From: Data East Pinball Service Department

Date: 2 April, 1993

Subject: Service Advisory/Ball draining from right to left

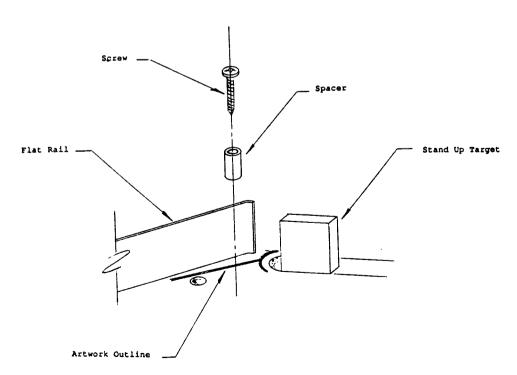
Symptom- Shooting the ball, using the left flipper to accomplish the right to left orbit shot, results in the ball exiting the playfield between the 2 Flippers.

Cause-The left flat rail may not remain properly aligned with the artwork due to the elasticity of the material and an insufficient number of support brackets on the side rail.

Femedy- Using the attached drawing as a guide, secure a small post with a #8x1" machine screw behind the left side of the flat rail. This is the area right above the Hat Trick Standup Targets. Before tightening the screw make sure the flat rail is properly aligned with the artwork.
